Hornsea Project Three
Offshore Wind Farm

Appendix 27 to Deadline 7 submission - Development of the
Cawston Traffic Intervention Scheme

Date: 14th March 2019

Figure 2.3: Option 1 (Revision 2) Cawston Highway Intervention Scheme included in REP6-015

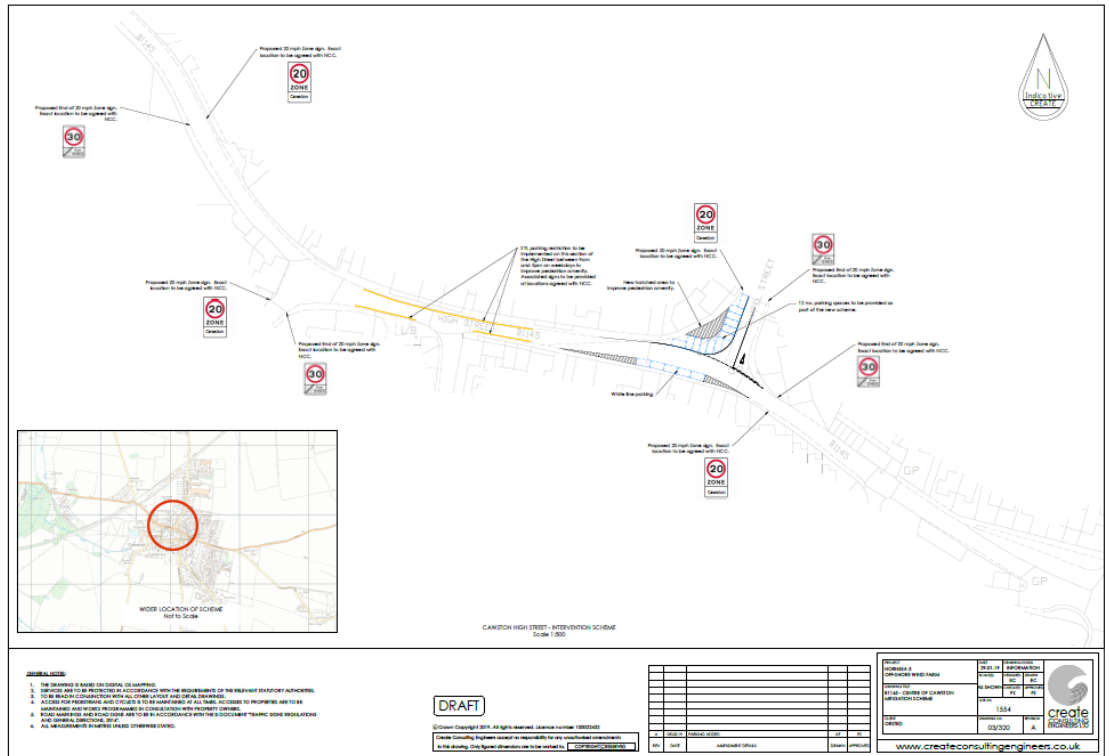
| Summary of Feedback from Norfolk County Council | Applicant's Response |
|--|---|
| Concerns were raised regarding the removal of on-street parking, both in respect to the provision of parking for local residents, but also the loss of the obstruction as a self-enforcing speed restrictor. | The Applicant revised the scheme to retain the existing parking provision on-street, albeit formalising the arrangement to avoid parking on the corner of junctions which currently occurs with the informal arrangement. |
| Concerns were raised regarding the proposed amendments to the parking within the centre of the village (opposite the delicatessant). NCC advised that they would be looking for any intervention scheme to retain the existing parking layout. | The Applicant revised the scheme to retain the existing parking arrangement. |
| It was suggested that the outline scheme be designed to naturally reinforce the speed restrictions through the village. | The Applicant revised the scheme to include on street parking and offer defined parking areas to assist with speed control in the centre of the village. |
| It was suggested that measures to improve pedestrian amenity be incorporated into the outline scheme, but soft landscape measures would not be supported. | The Applicant revised the scheme removing the landscape plans and introduced surface texture changes |
| It was suggested a 20mph zone could be supported but would need to cover a wider area than just the Village Centre. | The Applicant revised the plans to increase the extent of the 20mph speed limit to include the B1145 village limits. |
| Footway concerns were highlighted at the B1145 Cawston Primary School | The Applicant agreed to upgrade the existing footway to improve the width and crossing of the B1145 |

| DRAWING TITLE APPROACH DRIVER AWARENESS WORKS ON B1145 CAWSTON | | DRAWING No 03/322 | REVISION C | create CONSULTING ENGINEERS LTD |

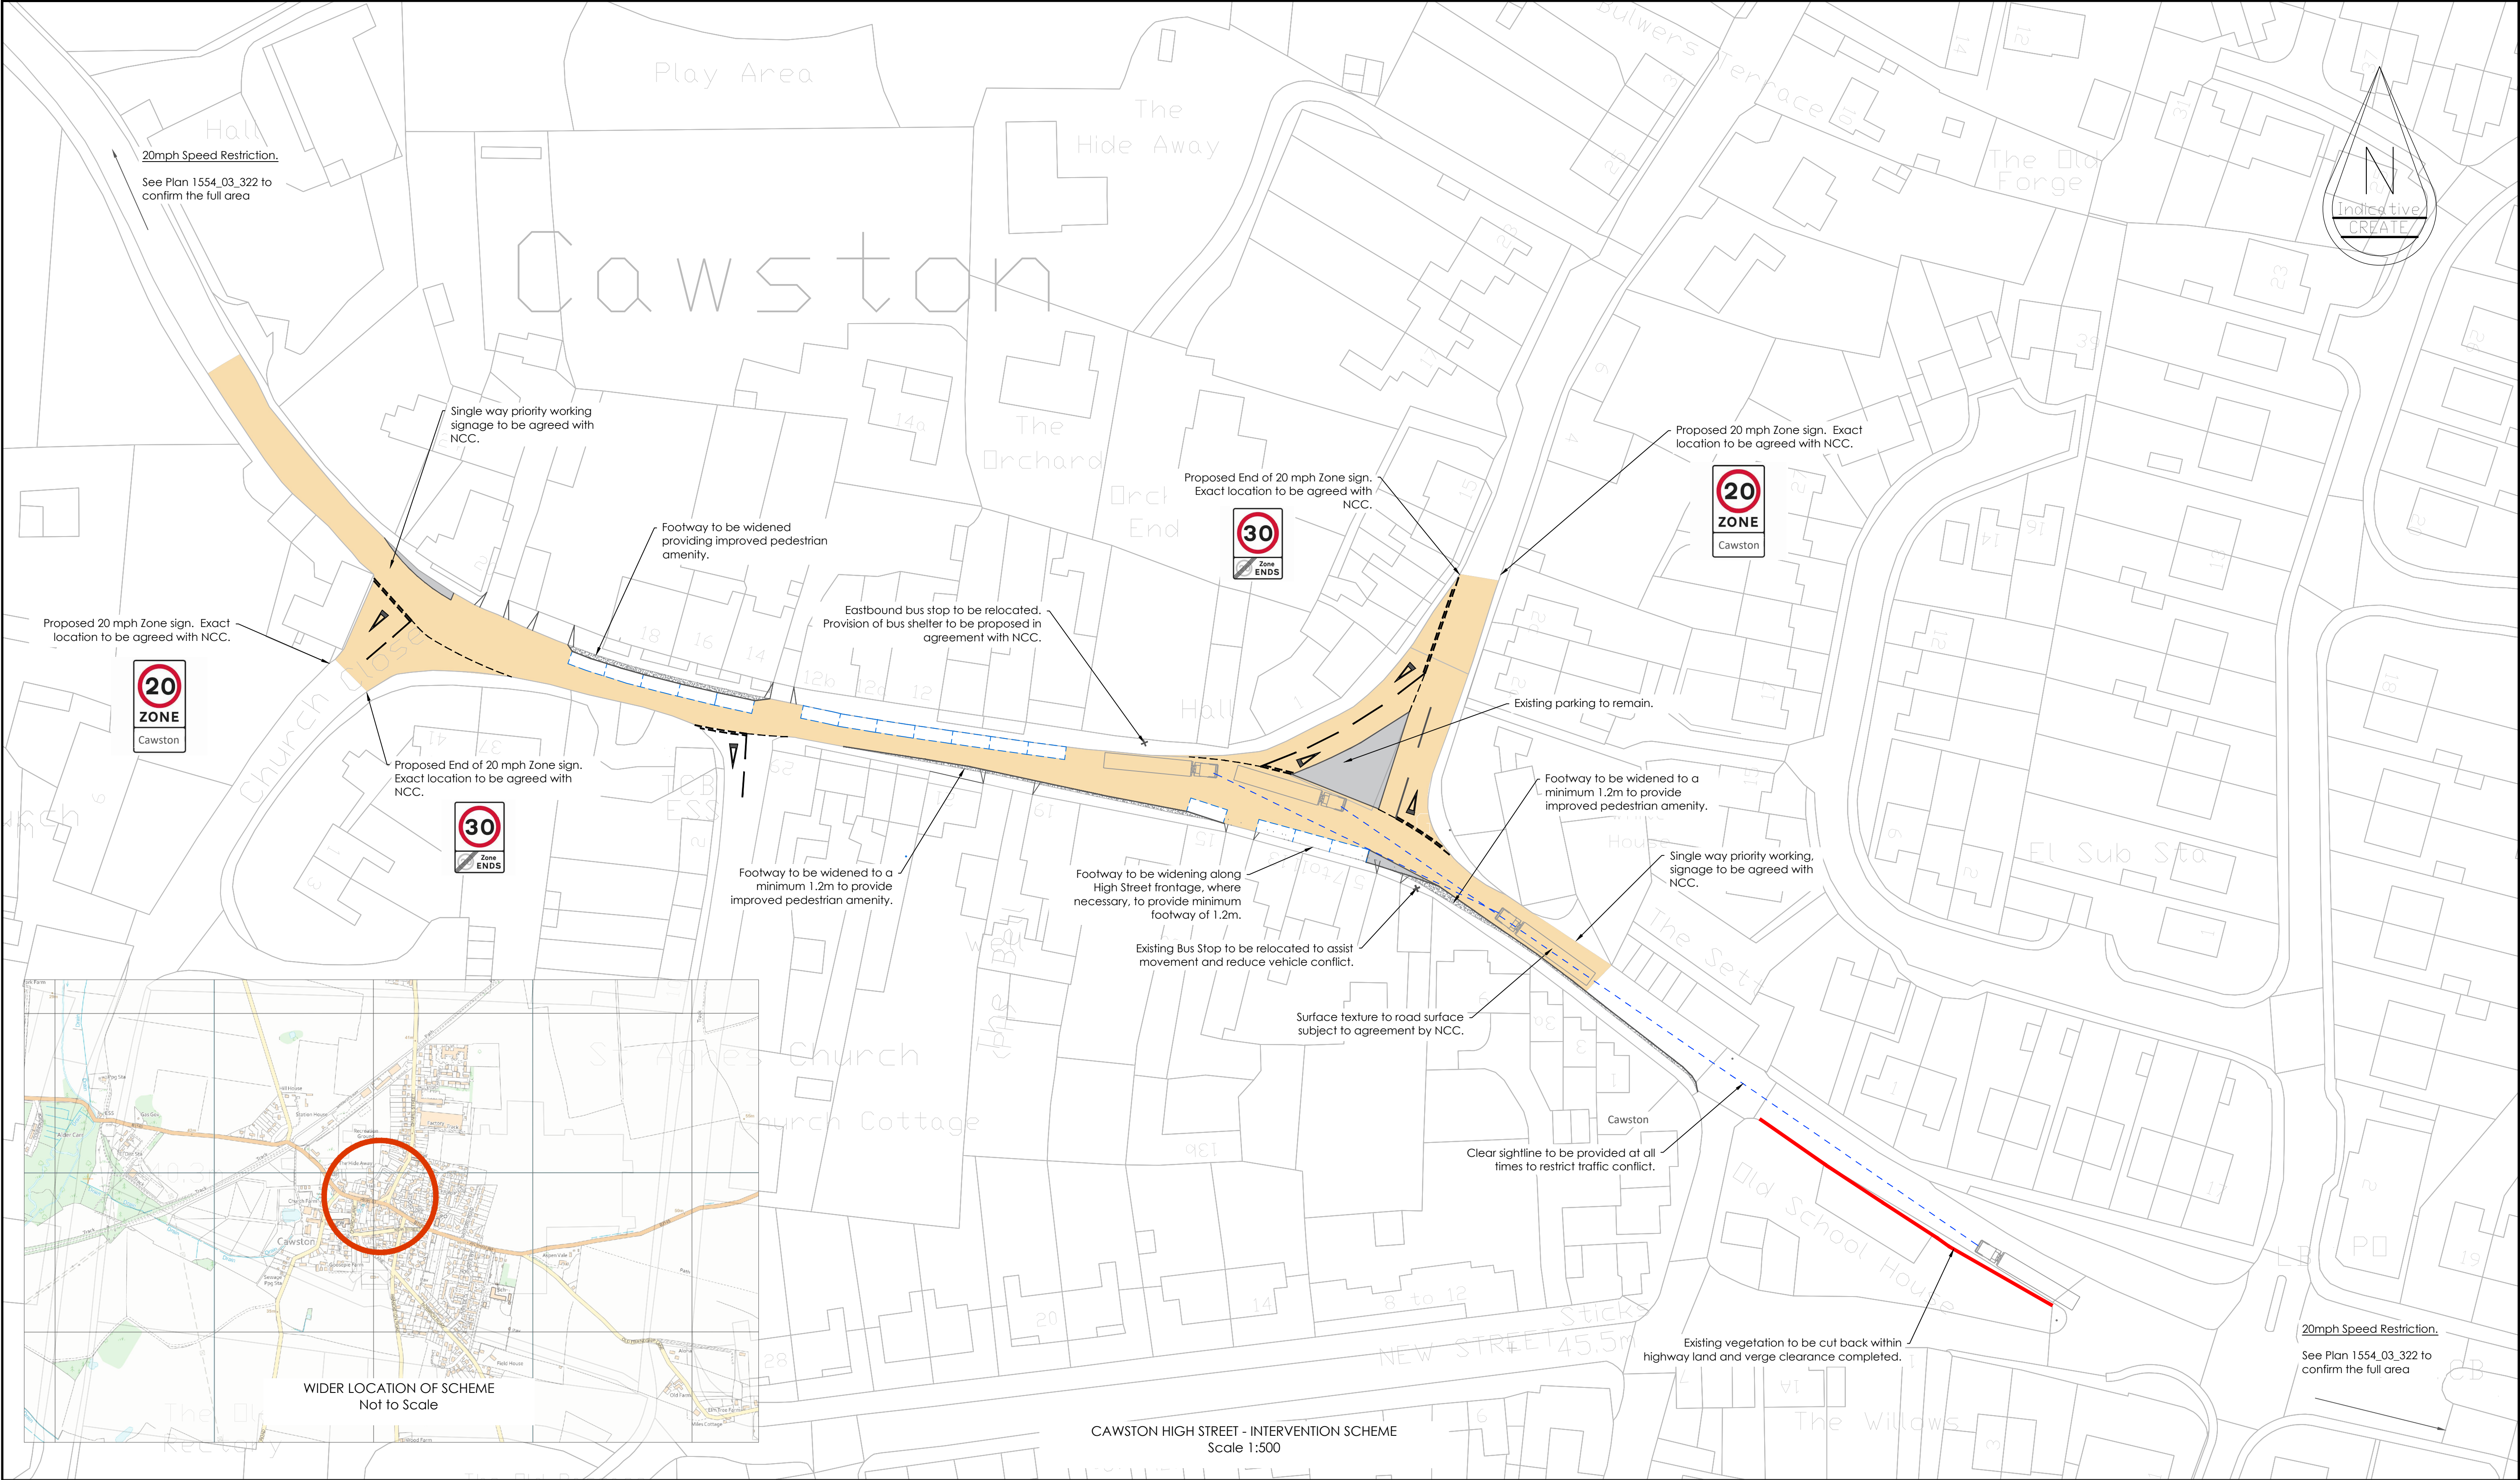
| Feedback from Stakeholder | Applicant's Response |
|--|--|
| It was requested that the 30 mph signage be located prior to entering the village. | The Applicant has incorporated this feedback into Revision 3 of the proposed outline intervention scheme. |

| DRAWING TITLE B1145 - CENTRE OF CAWSTON MITIGATION SCHEME | JOB No | 1554 | |

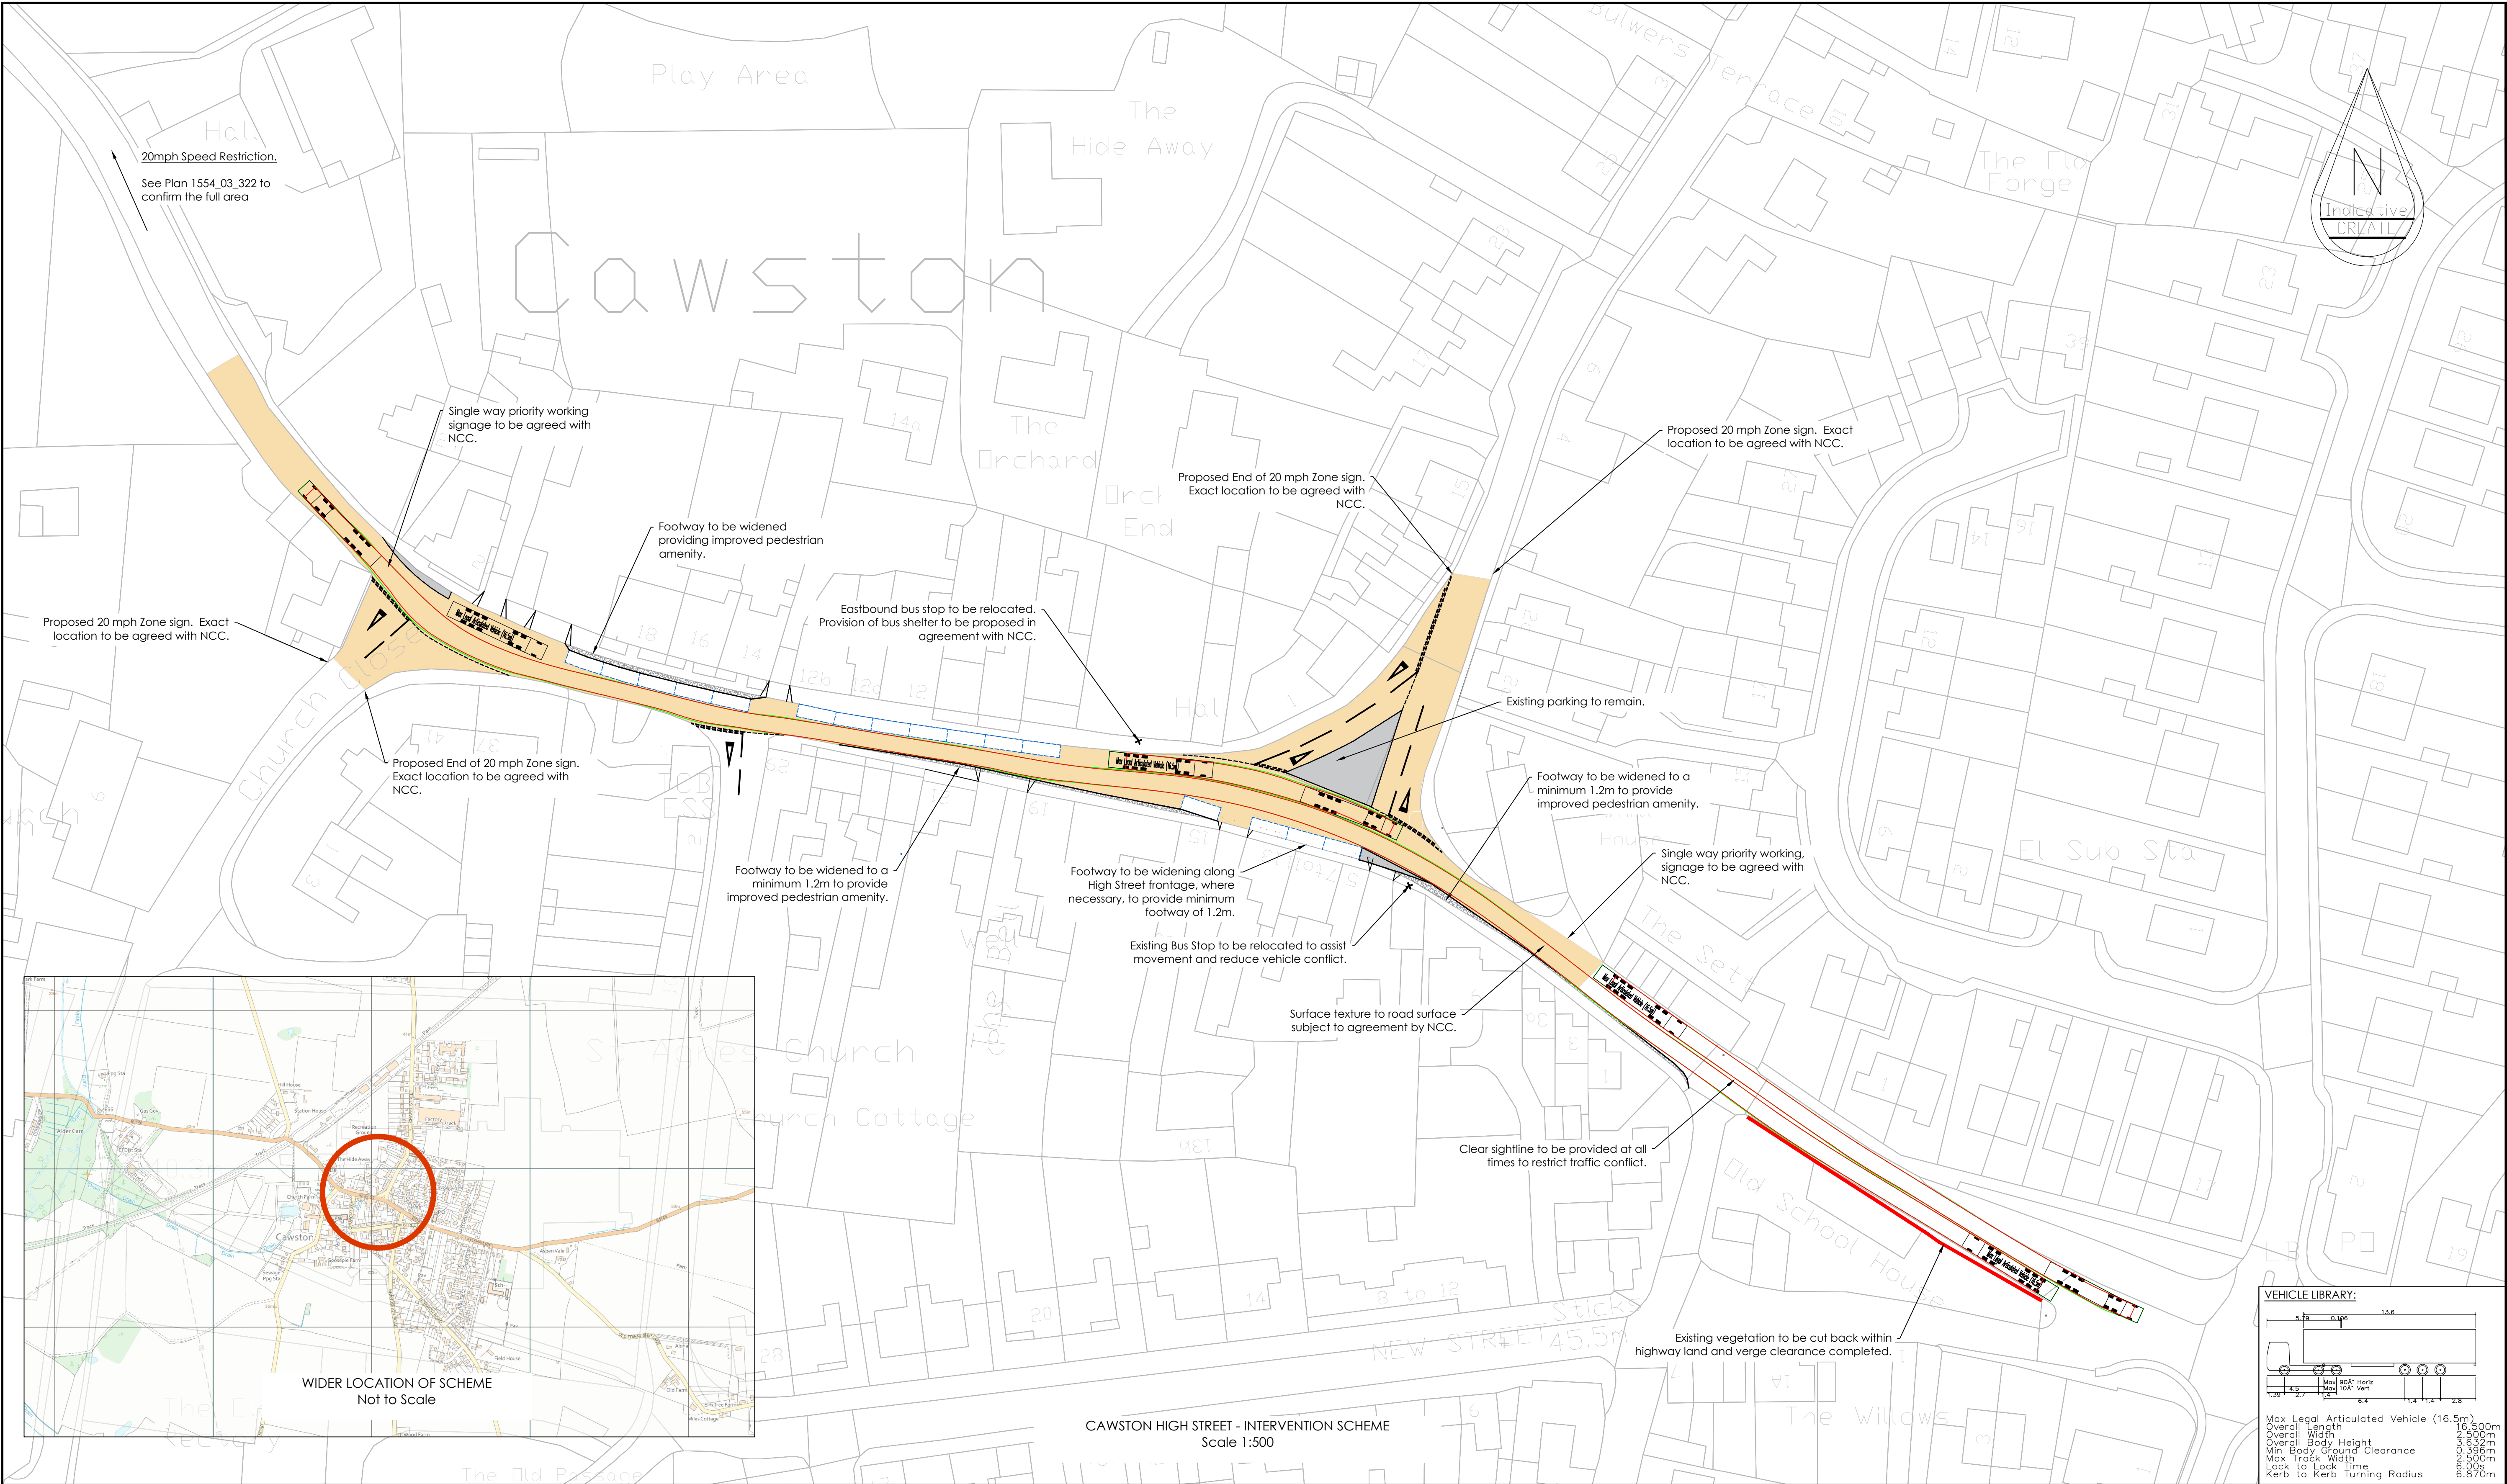
| Feedback from Stakeholder | Applicant's Response |
|--|--|
| <p>Concerns were raised about the safety of children, elderly people, wheelchair users and people with pushchairs using foot paths with additional HGV traffic. Requests were made for additional pedestrian path widening, including locations close to the delicatessen.</p> | <p>The Applicant has revised the scheme to include changes to footway width and parking locations for safety and residential amenity. These measures are all incorporated into Option 1, Revision 4 as shown in Annex B.</p> |
| <p>It was requested that the implications of moving the bus stop be considered. This was particularly in relation to the school buses to Reepham High.</p> | <p>The relocation of the bus stops offers an improvement to the current poor footway provision. The Applicant has highlighted footway widening improvements which add a greater level of protection for both embarking and disembarking bus users, whether for school travel or public bus services. Aligned with the planned 20mph speed limit measures to improvement the driver sightline the Applicant believes the planned intervention scheme offers local benefit.</p> |

| Feedback from Stakeholder | Applicant's Response |
|--|--|
| Concerns were raised about the potential for congestion as a result of maintaining car parking along the High Street. | <p>As noted in Table 3.1, in order to maintain a balance between highway capacity and self-enforcing traffic management, parking has been retained within the centre of Cawston. However, this seeks to formalise the existing arrangement to avoid parking on the corner of junctions which currently occurs with the informal arrangement. This is reflected in Option 1, Revision 4 of the outline intervention scheme as shown in Annex B. Any traffic intervention will be subject to a full safety audit prior to approval.</p> |
| Requests were made to maintain the existing parking, for residents, users of the local businesses and as a natural speed restrictor. Concerns were raised about the perceived safety of parking. | |
